## STAFF REPORT FOR THE HISTORIC REVIEW BOARD

**FILE NUMBER:** DR-17-02

**REQUEST:** Class II Design Review to construct a new home and detached garage in the Historic District Overlay Zone at 1689 6<sup>th</sup> Avenue

**Figure 4: Front Yard Setback**

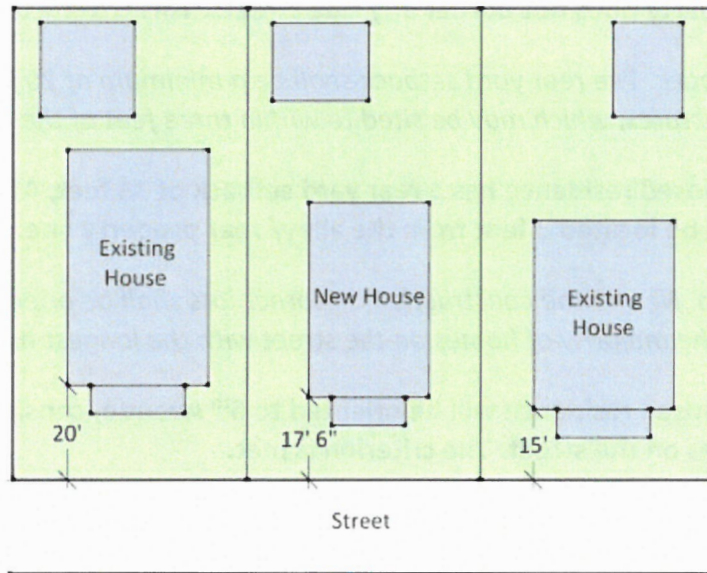
**Finding 13:** The applicant is proposing a setback of 20 feet to the front of the house and setback of 14 feet to the front of the porch. The front setback would be the average of 20 feet, which is generally required in the R-5 zone, and the adjacent property. The porch is allowed to extend into the setback six feet from the dominant vertical face of the building. The unenclosed front porch does not have any living space above. The criterion is met.

SHEET  
**1**

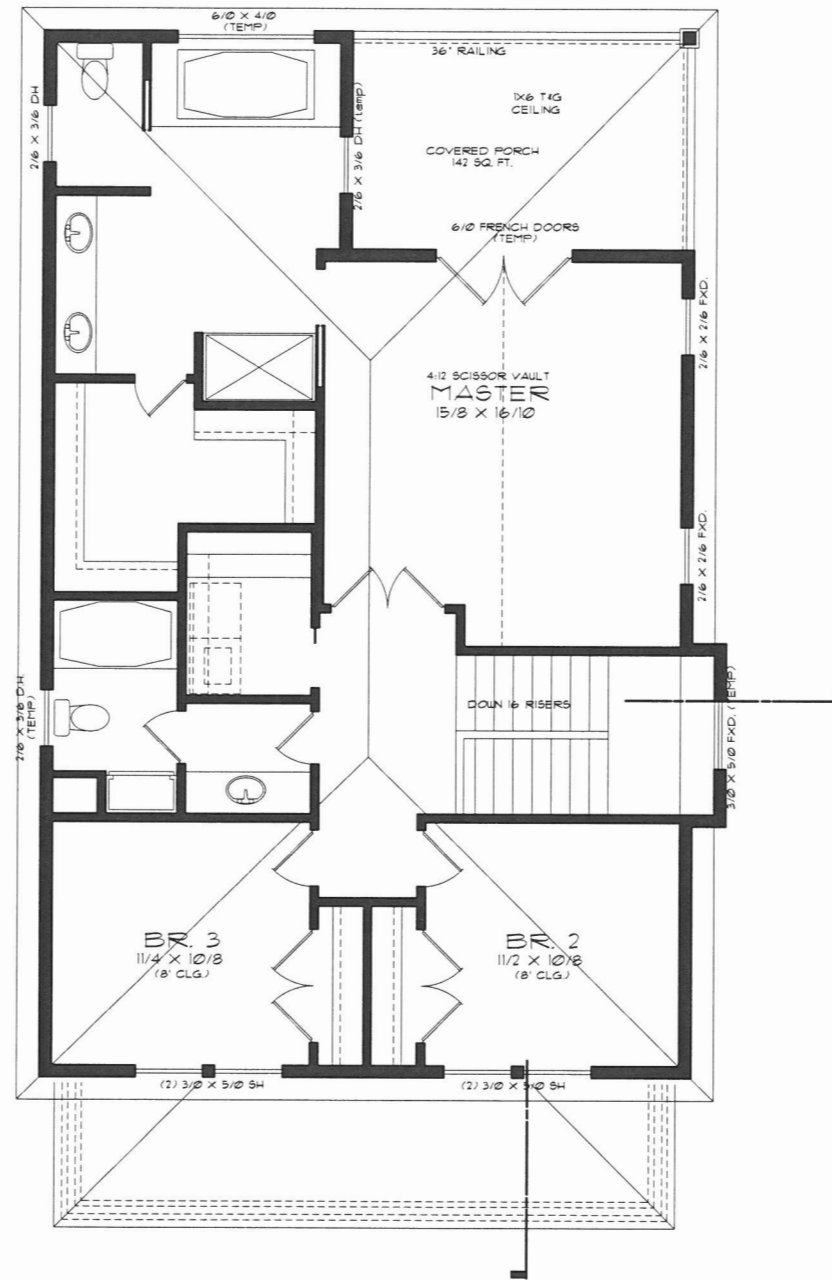
**Finding 7:** The applicant is proposing single-hung paint grade windows with clear glass (low E as per building code). The windows under the front porch will be the only windows to have muntins in the upper portions of the windows (see submitted plans sheet 1). Windows throughout the proposed home will have mullions (see submitted plans sheet 1). No storm windows are proposed. The criterion is met.

**Finding 10:** The applicant is proposing two decks on the rear elevation, behind the main part of the house, on both the first and second floor (see submitted plans sheet 1). The criterion is met.
